SECTION 00 91 15

ADDENDUM NUMBER 6

- 1.01 DATE: APRIL 6, 2021**
- 1.02 PROJECT: WELCOME CENTER**
- 1.03 PROJECT NUMBER: DCM NO. 2020604**
- 1.04 OWNER: ALABAMA A&M UNIVERSITY**
- 1.05 ARCHITECT: NOLA | VAN PEURSEM ARCHITECTS, PC**

SHEET NUMBER
C803
13 OF 17

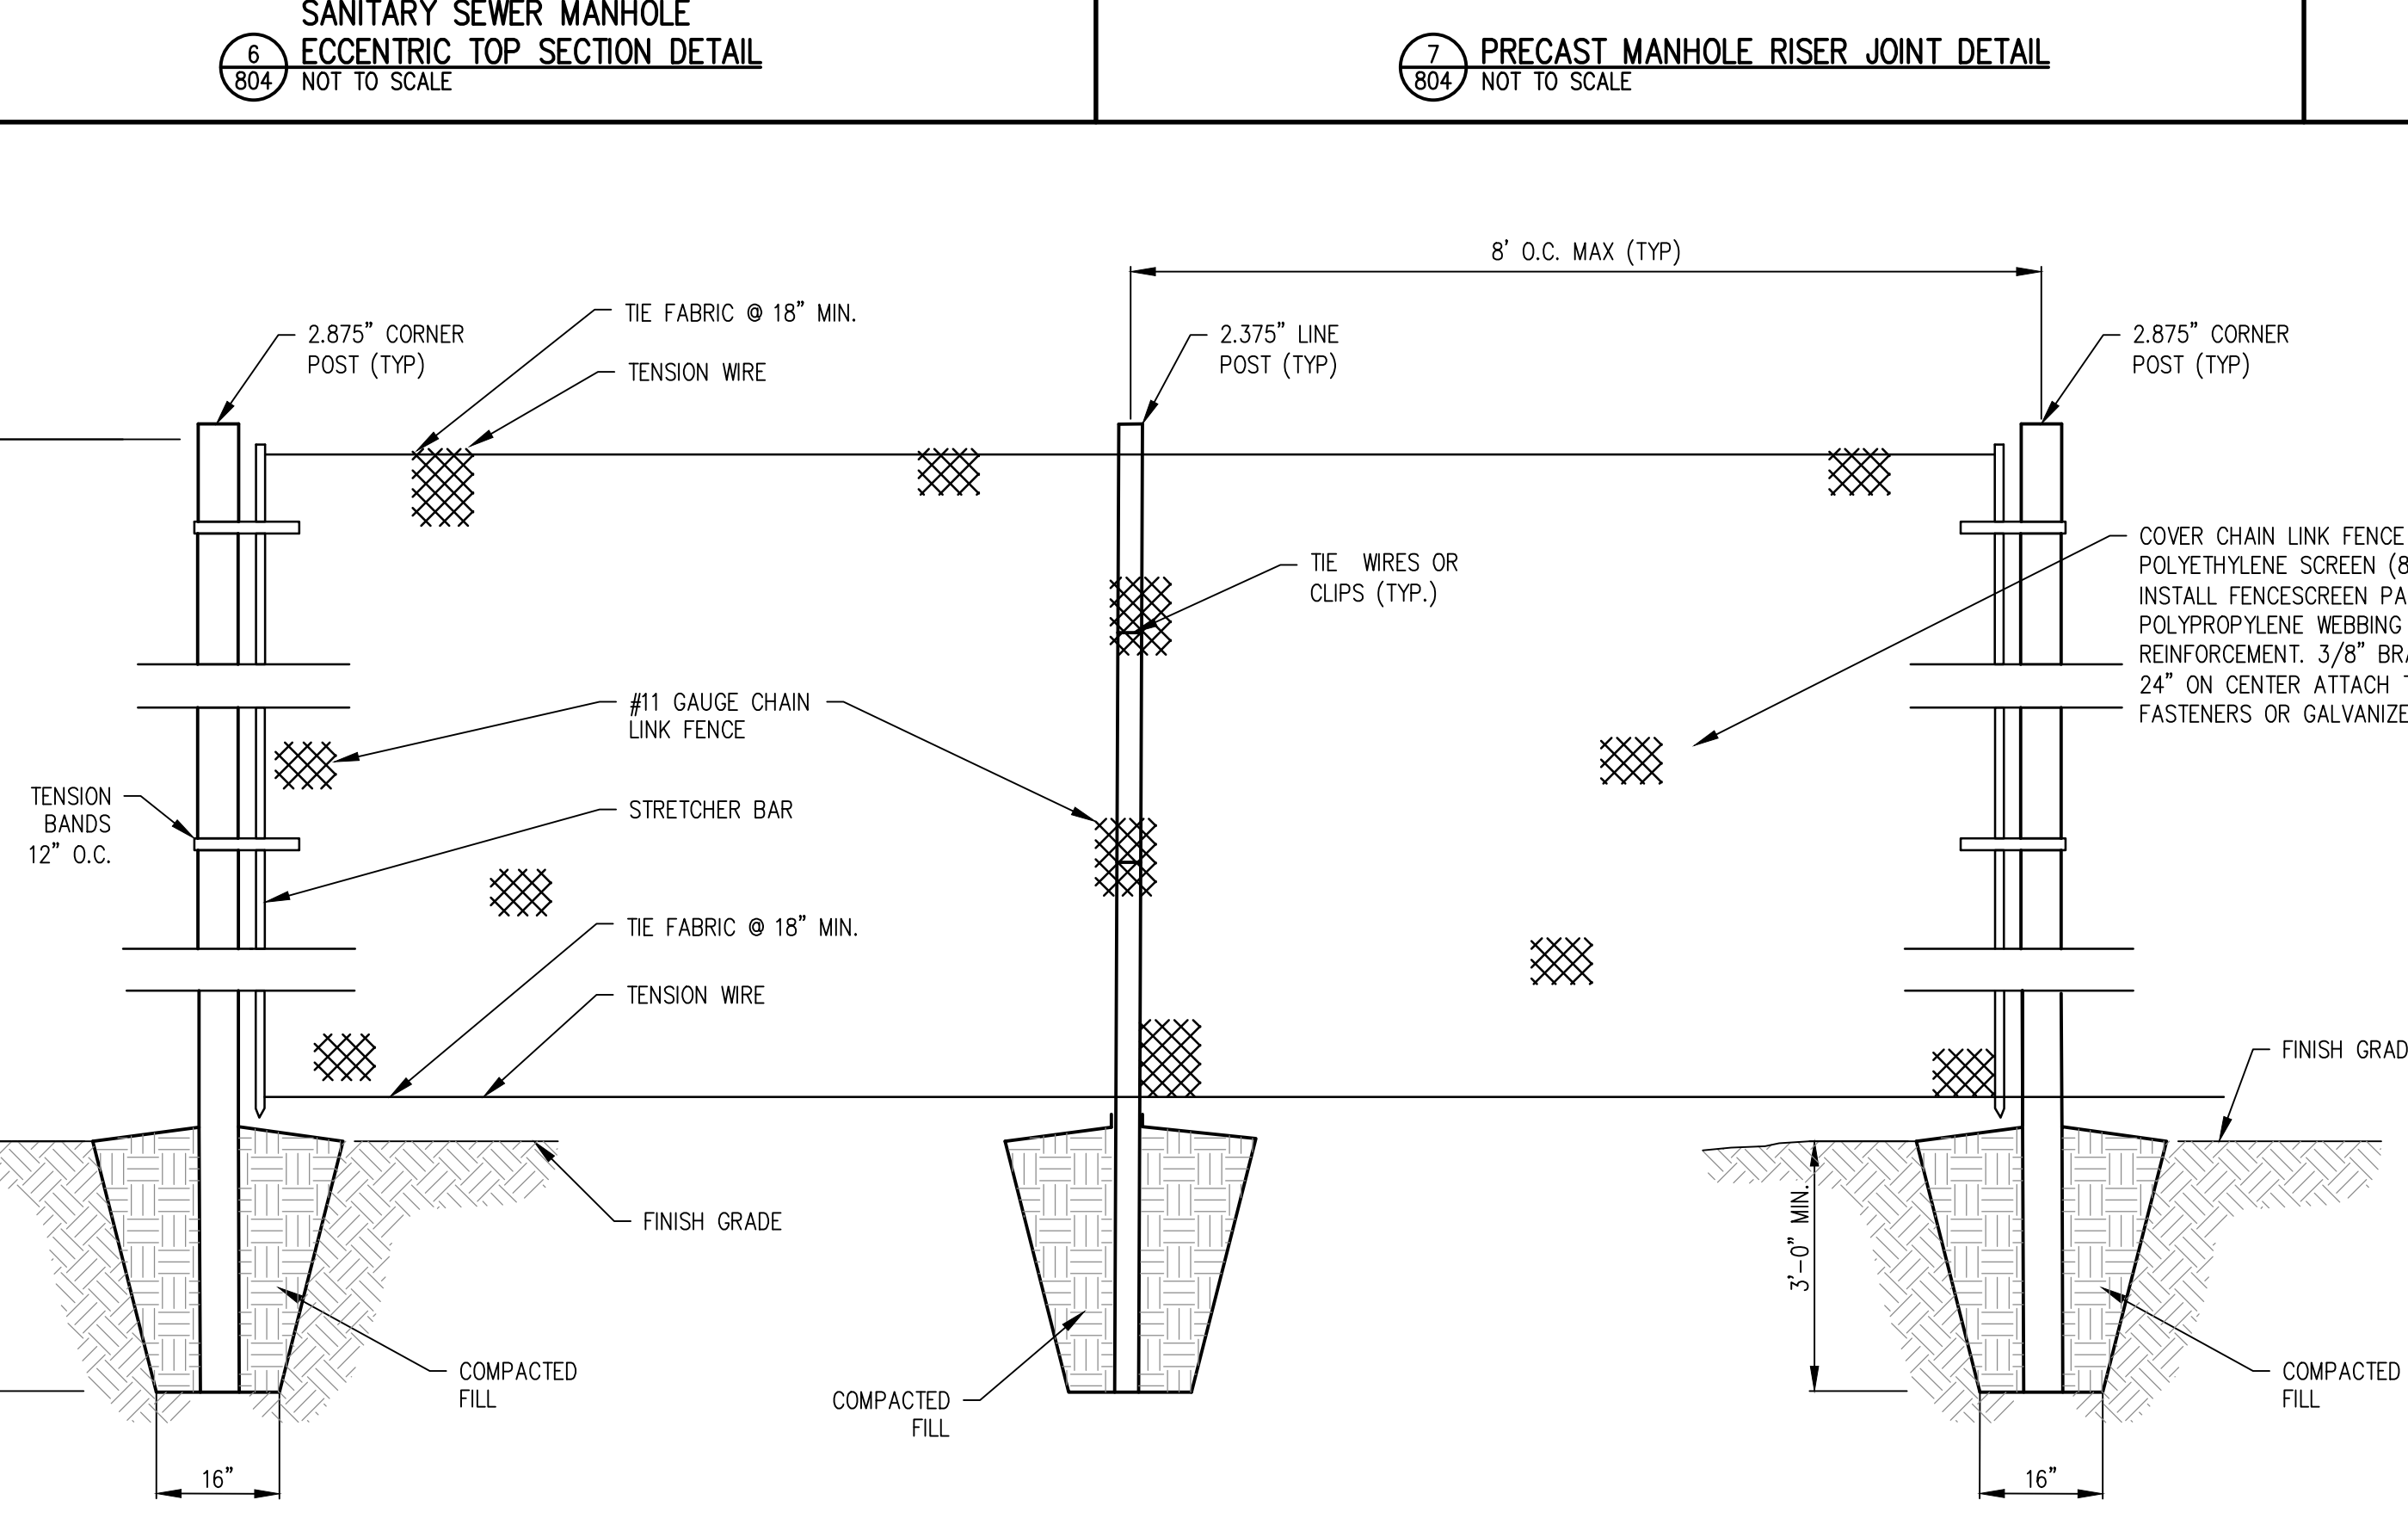
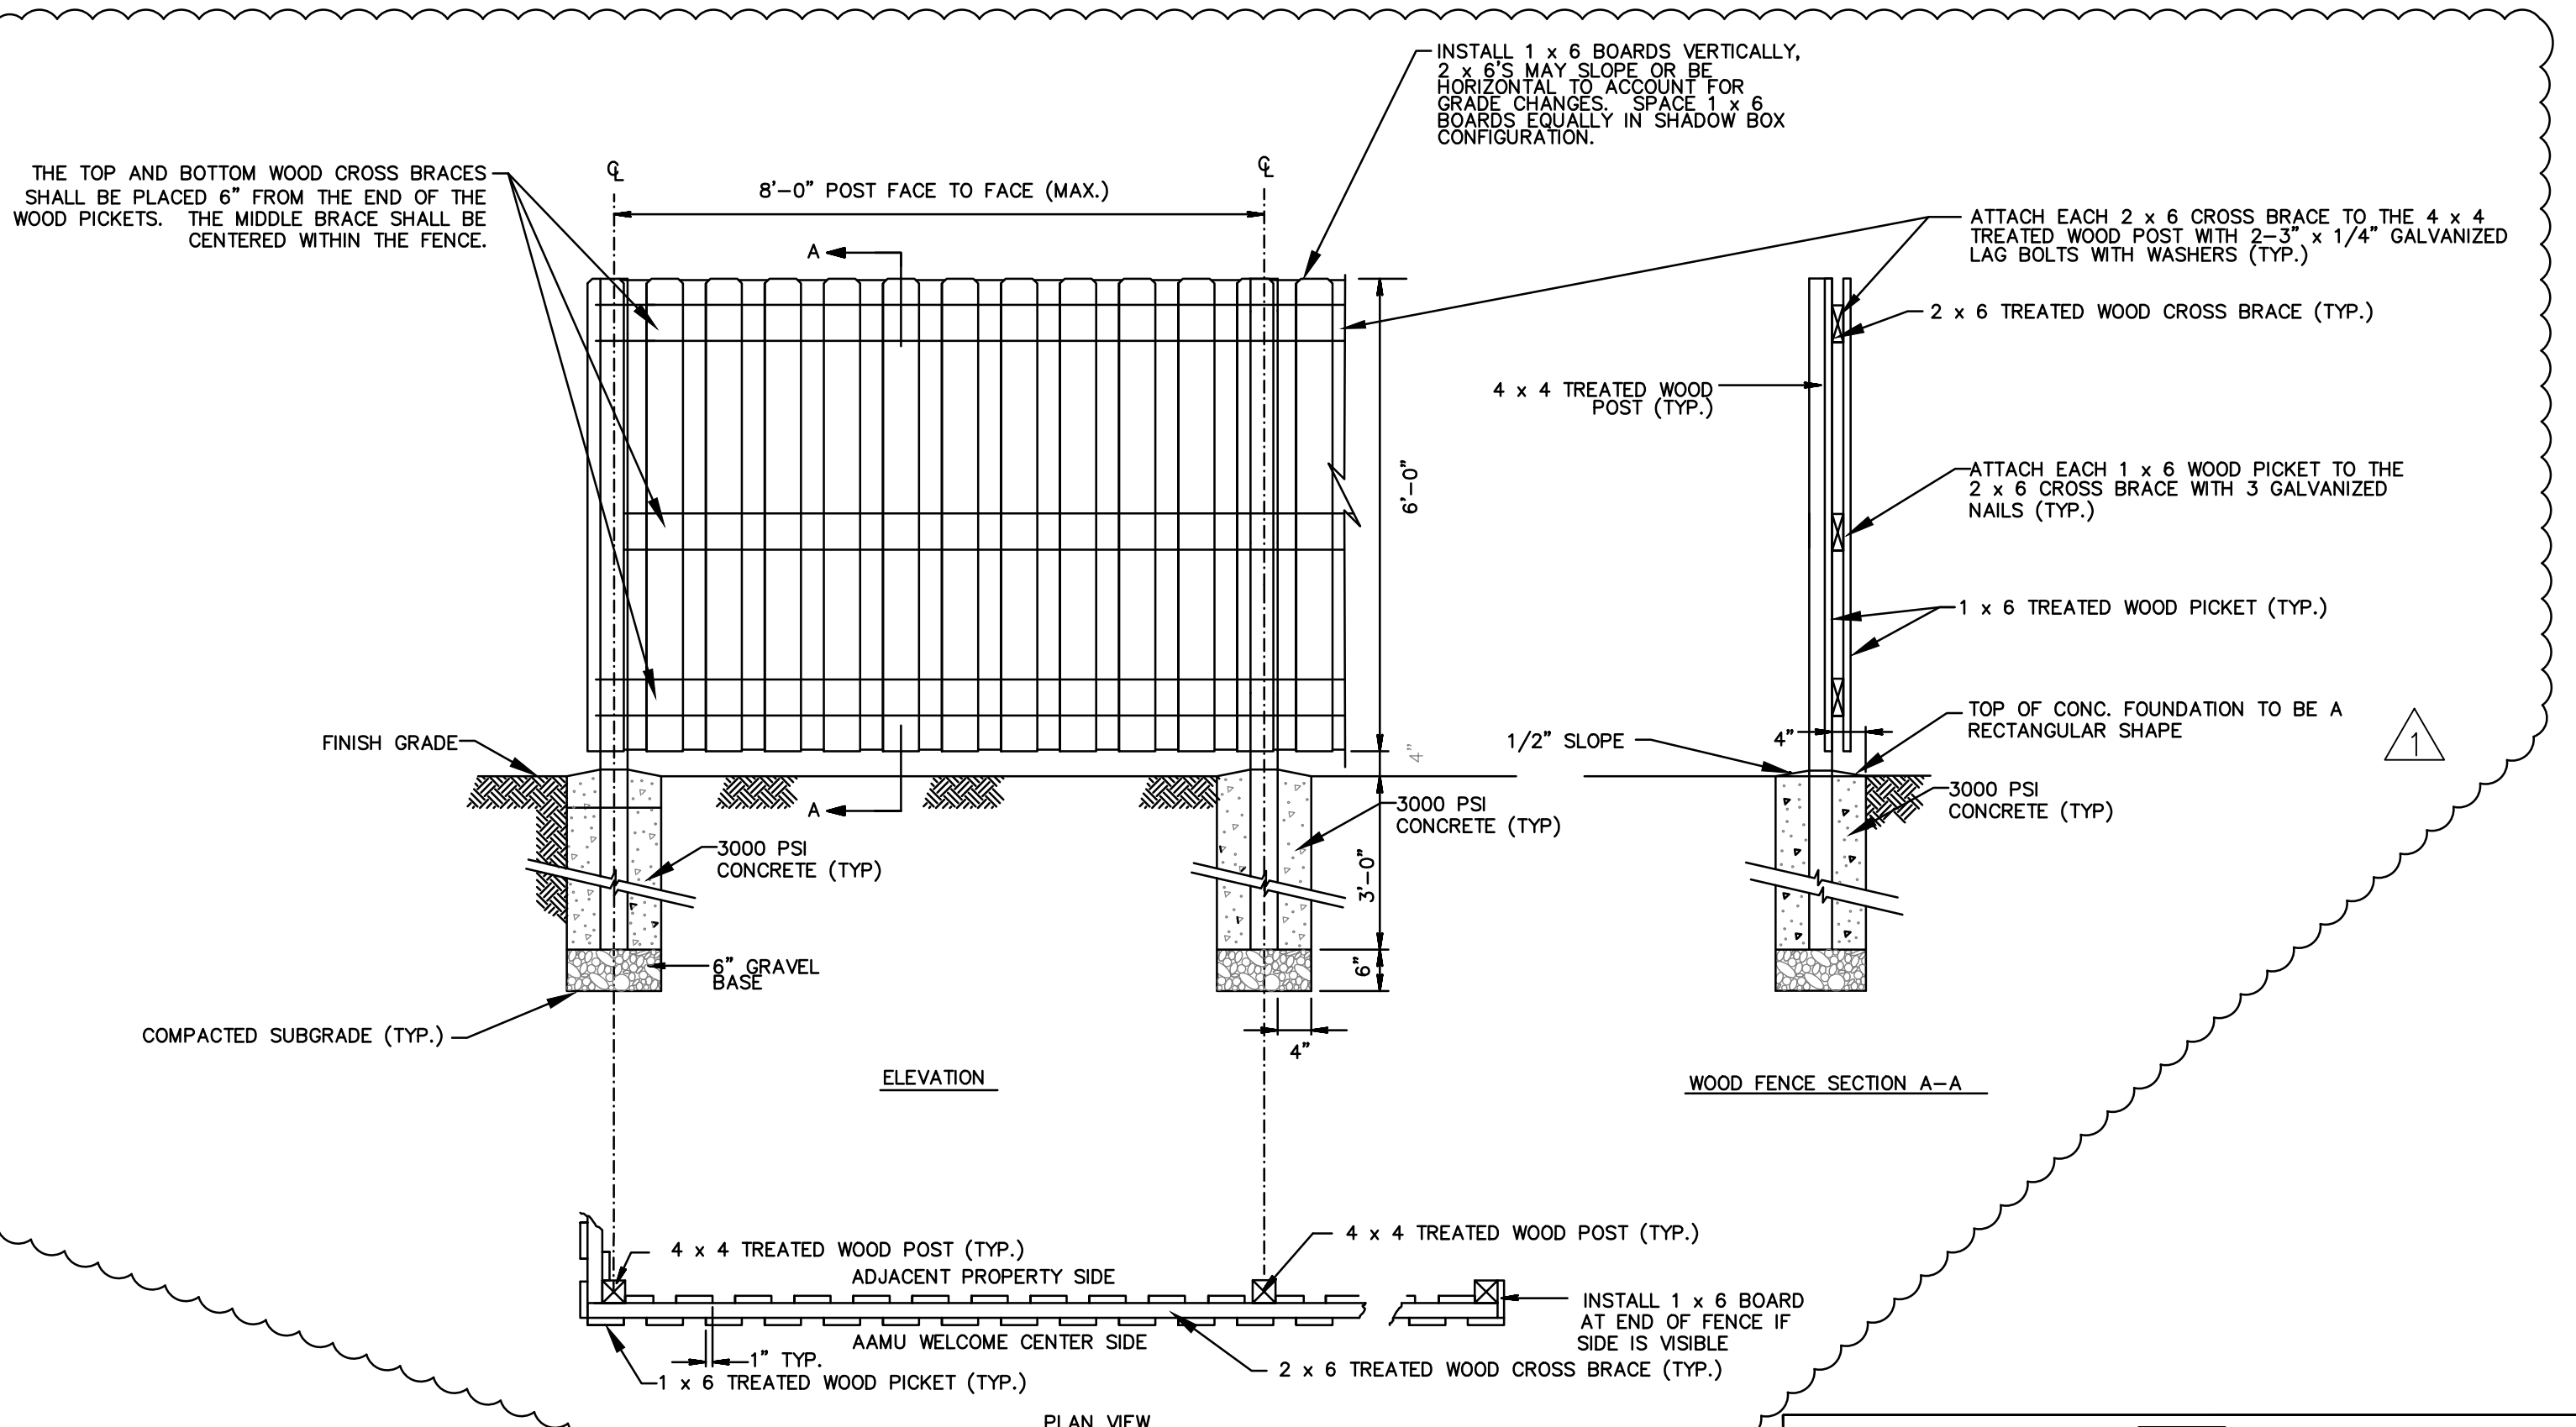
4.03 SHEET C803 – CONSTRUCTION DETAILS:

- A. Replace this Sheet in its Entirety. Revisions include the following:
1. Modified Detail 7/803-Fire Main Connection Detail to show the public fire hydrant material & installation is by Huntsville Utilities.
 2. Change the connection point for the private fire hydrant line.
 3. Clarified that the contractor shall provide and install all materials required for the private fire hydrant line and fire hydrant as shown on sheet C701.
